**Monks Orchard Residents'  
Association  
Planning**

Reference	22/05090/FUL
Application Received	7 Dec 2022
Application Validated	7 Dec 2022
Address	77 Woodmere Avenue Croydon CR0 7PX
Proposal	Demolition of single-family dwelling and garage; erection of a detached 2-storey building with accommodation in the roof space, comprising: 6 self-contained flats, 7 car parking spaces, refuse store, cycle parking, and communal amenity space.
Consultation Expiry:	20 Jan 2023
Decision Deadline:	01 Feb 2023
Case Officer:	Ms. Jeni Cowan

Please accept this letter as a formal objection to **Application Ref: 22/05090/FUL** for the Demolition of single-family dwelling and garage; erection of a detached 2-storey building with accommodation in the roof space, comprising: 6 self-contained flats, 7 car parking spaces, refuse store, cycle parking, and communal amenity space.

#### Application Parameters for 77 Woodmere Avenue Area Type Setting

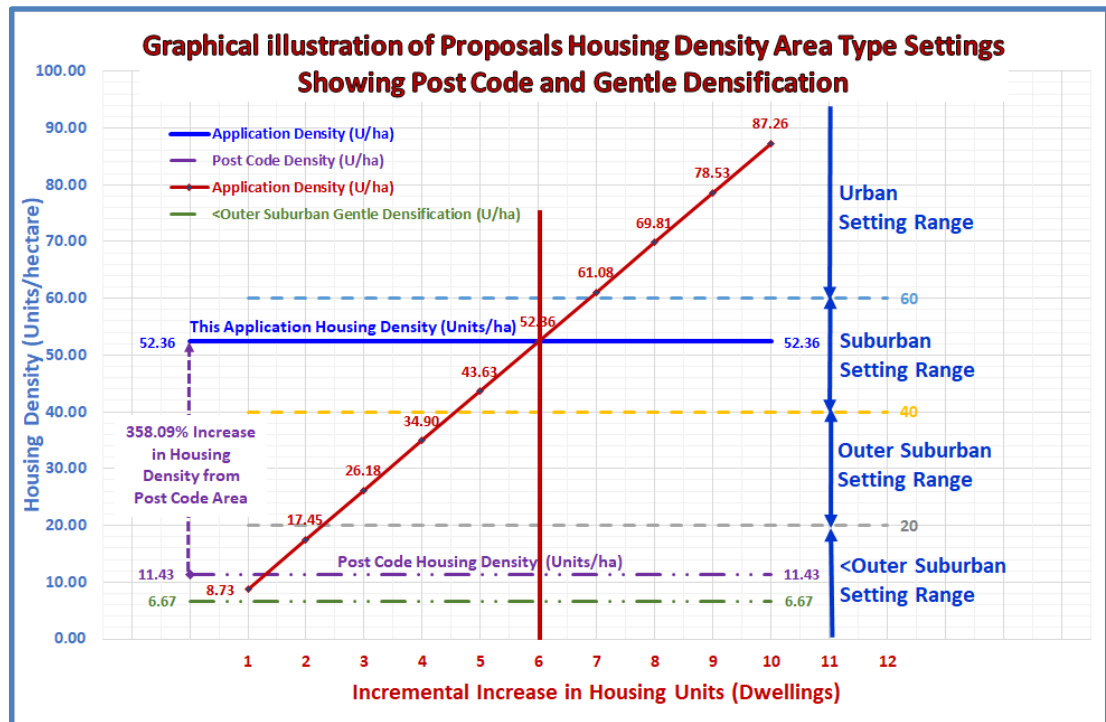
The proposed application **Housing Density** at **52.36Units/ha** places the appropriate **Area Type Setting** required at a **“Suburban Setting”** when the **Area Type Setting** for the locality as defined by the **Local Post Code CR0 7PX** is **11.43Units/ha** which is actually **“<Outer Suburban”** **Area Type Setting** with a Low **PTAL** of **1a**. The proposal would present a **358.09%** increase in **Density** from the **Local Post Code Housing Density** as assessed and in accordance with the **National Model Design Code & Guidance**.

This increased density cannot be logically construed as appropriate for the locality at a low PTAL of 1a, even within a **“Gentle”** Densification by any stretch of the imagination. The increased Density therefore is unacceptable.

**Graphical analysis of <Outer Suburban Area Type Setting with estimated "Gentle" densification, "Moderate" and "Focussed" Intensification toward Outer Suburban Area Type Setting.**

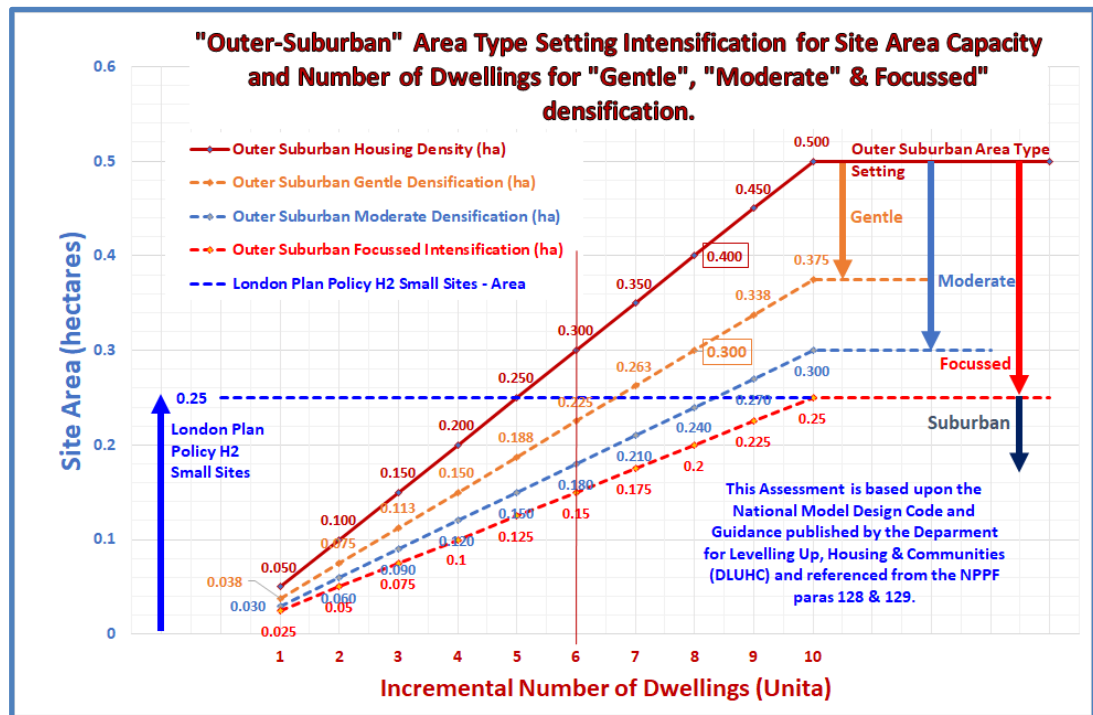
6.6.2 This analysis and assessment illustrates the proposal is a significant over development for the locality based on **National Planning Policies** as defined in the **National Model Design Code & Guidance**. Therefore, this proposal should be Refused.

6.6.3 The graphical illustration above shows the appropriate **Site Area** in hectares for **<Outer Suburban "Gentle" densification** requirement for **6 Units** is **0.9ha** when the actual **Site Area** **0.1146ha**. This shows that the **Site Area** is deficient by **0.7854ha** to meet the **Site Area capacity** for **6 units** allowing for **"Gentle" densification** in an **<Outer Suburban Area Type Setting** as defined by the local **Post Code Area Type Setting**.

**Graphical Illustrations of the proposed Residential Density in relation to the Post Code and Area Type Setting**

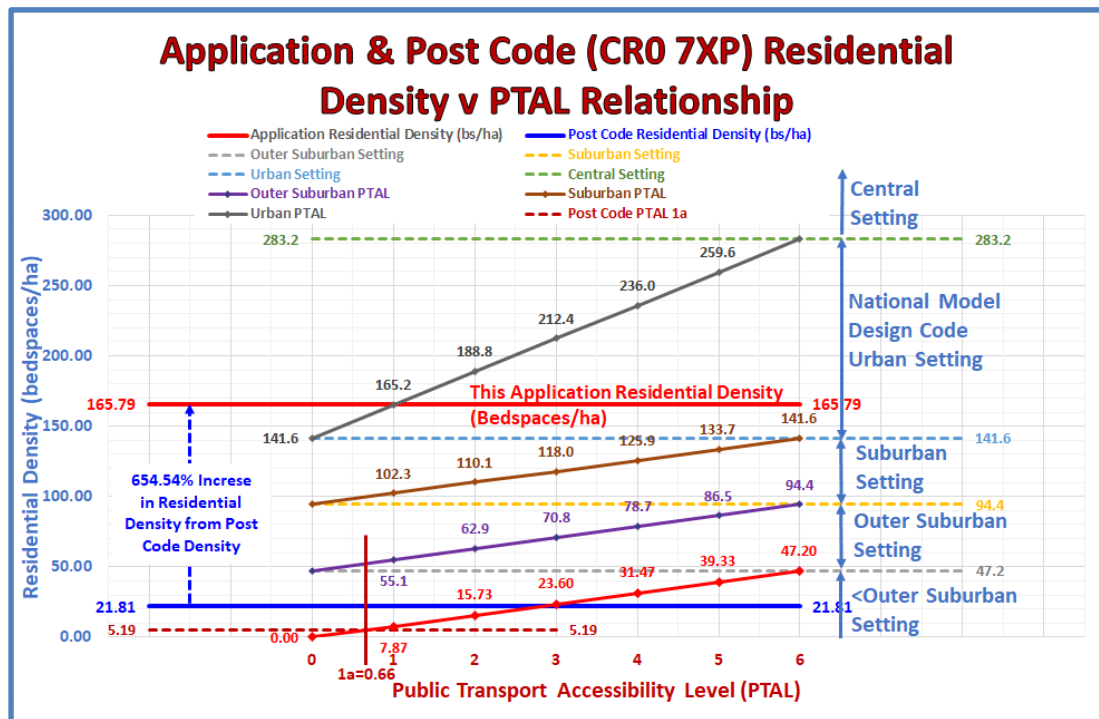
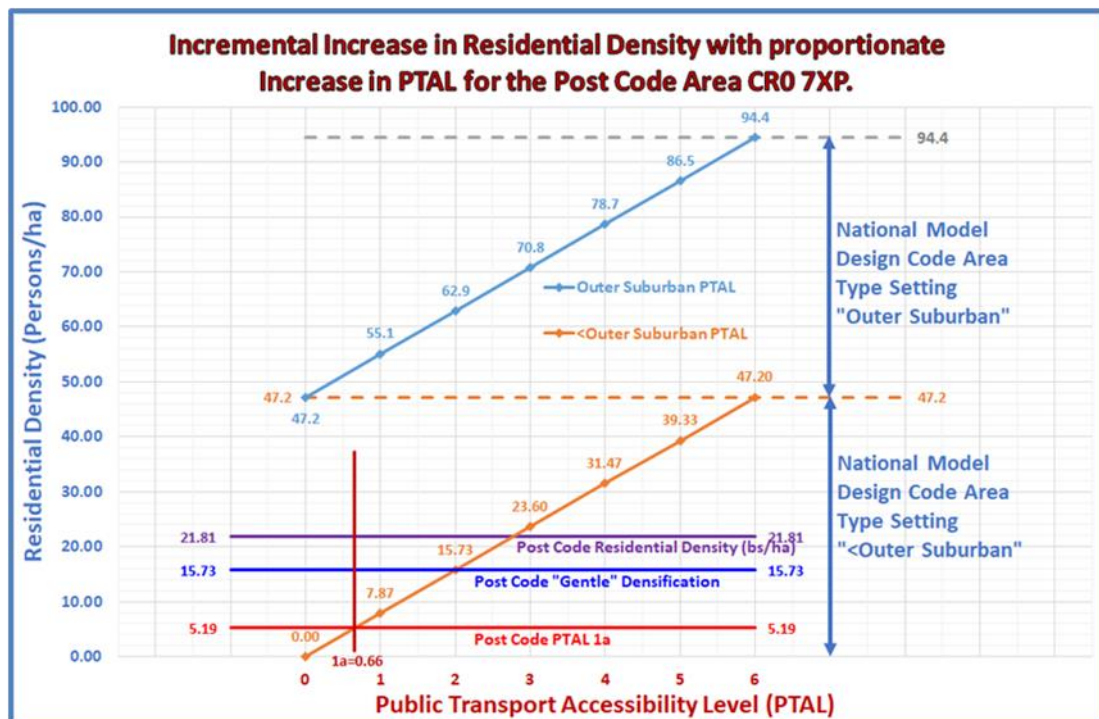
7.5 The Level of Supporting Public Transport Accessibility (PTAL) across the Area Type Setting from PTAL Zero to PTAL Max (6) and the suggested levels of Densification/Intensification are shown in these graphical illustrations.

- 7.6 The first graphical illustration provides the **Residential Density v PTAL** comparison between the offered **Residential Density** and the accepted appropriate **Residential Density** for the **Local Area Type Setting** as defined by the **Local Post Code** and the second Graphical illustration shows the **Residential Density v PTAL** relationship for an **<Outer Suburban** Setting in more detail.

- 7.7 For this proposal, the **PTAL** for an **<Outer Suburban** “Gentle” **Densification** should be **≈5.19bedspaces/ha** (persons/ha). The **Post Code Residential Density** for this locality **CR0 7XP** is **21.81bs/ha** (≈22) but the actual proposal **Residential Density** is **165.79bs/ha**, an enormous **654.54%** increase on the **Post Code Density** for the Area; i.e., this density would be more appropriate in a **“Urban”** Area Type Setting, than an **“<Outer Suburban”** Area Type Setting. The appropriate **Post Code Density** for **PTAL** at **1a**  $\equiv$  **0.66** would be **5.19bs/ha** (≈5), increasing to **15.73bs/ha** for “Gentle” densification. This is a further indication of significant over development for the **Site Area** and the **Area Type Setting** as defined by the **National Model Design Code & Guidance**.

**Illustration of 45° Rule vertical from the Centre of the nearest Ground Floor Window/Door of 79 Woodmere Avenue (Distances provided by the Occupant) fails to meet the requirement.**

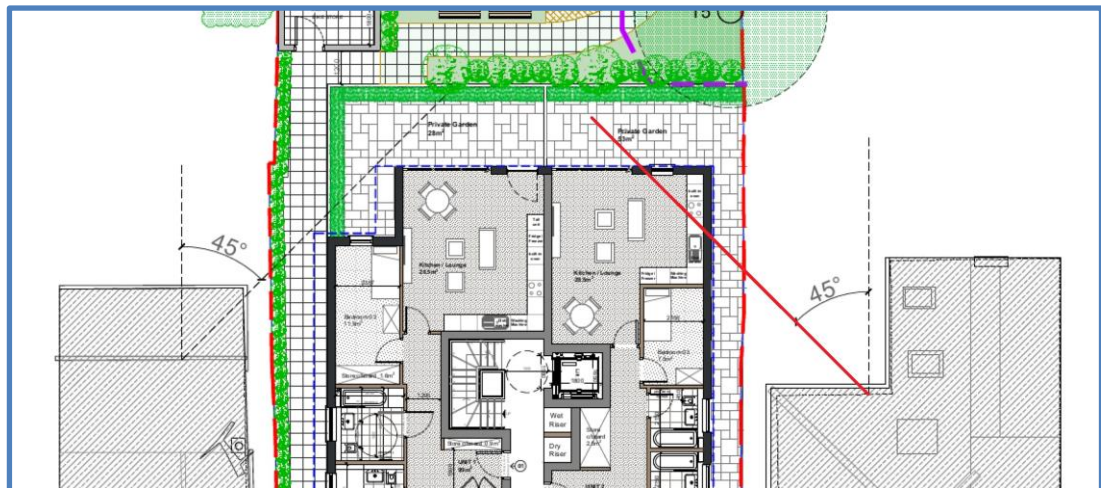
- 8.1.2 The Illustrations below show the **failure** of both the **Vertical** and **Horizontal 45° Rule projection** from **79 Woodmere Avenue** intersects the proposed development and therefore fails to meet the **London Plan Supplementary Planning Guidance – Small Site Design Codes** para 4.1.12.

**Ground Floor Site Layout plans show the failure of the 45° Rule Horizontal projection from 79 Woodmere Ave intersects the proposed development at 77 Woodmere Ave.**

- 14.3 The increased roof height of the proposal has **exacerbated** the loss of amenity to **79 Woodmere Avenue 45° Rule** (vertical) projection and the projected intersection from that of the refused previous proposal. Also, the horizontal **45° Rule** projection and intersection from **79 Woodmere Avenue** is virtually identical to that of the previous refused proposal and again fails the projection intersection requirement.

**Parking Provision**

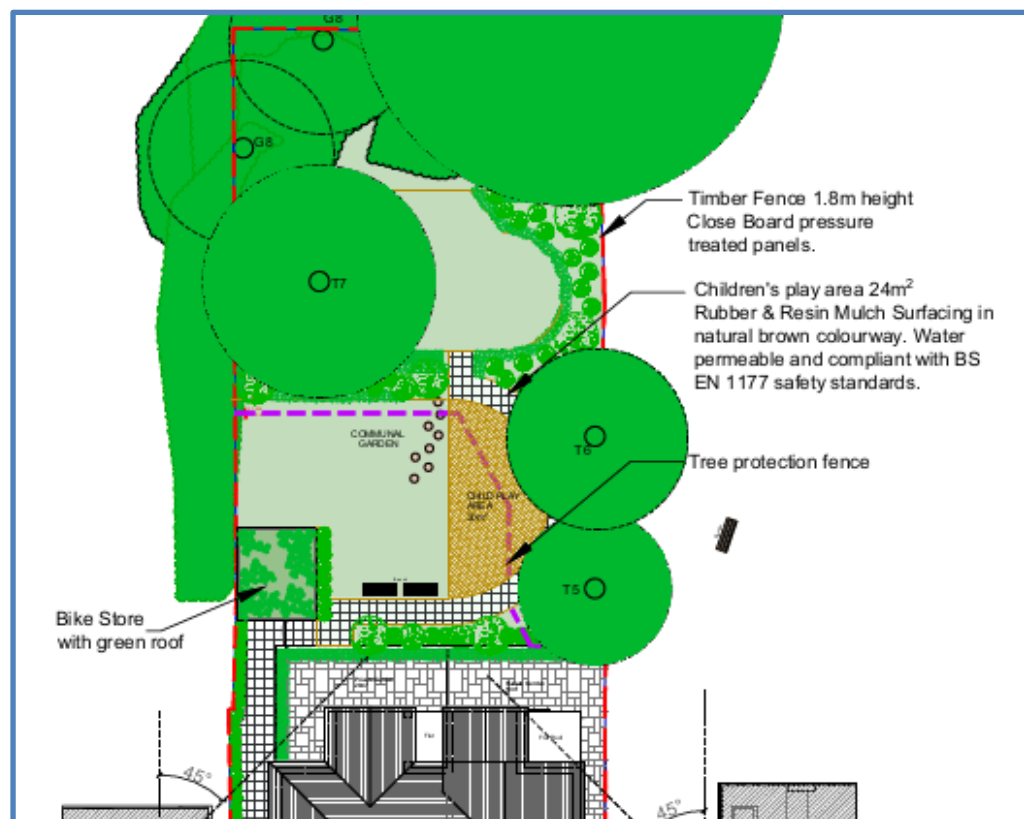
10.1 Both the **London Plan** and the **Revised Croydon Local Plan** provide Parking provision guidance of **1.5 spaces for 3 or more Bedroomed Units** and **1 space for <3 Bedroom Units** giving a total recommended guidance of up to **7.5 spaces**. **7 spaces** are provided in the proposal.

- 10.2 There are no **swept path diagrams** to show accessibility and manoeuvrability. It is considered **Bay 4** and **Bay 5** would have the most difficulty in ingress and egress to ensure exit over the footpath in a forward gear as there is limited lateral facility within the bay. As such, it is suggested that **Swept paths** be provided for both ingress and egress to/from **Bays 4 & 5** with all other Bays occupied, to illustrate the acceptable manoeuvre for exits over the footpath in a forward gear.
- 10.3 **One space** is for **Disabled Vehicle Bay** in support of **Plot 1 to M4(3)** regulation and **Bays 2 & 4** are to be provided with **EVC Points**.
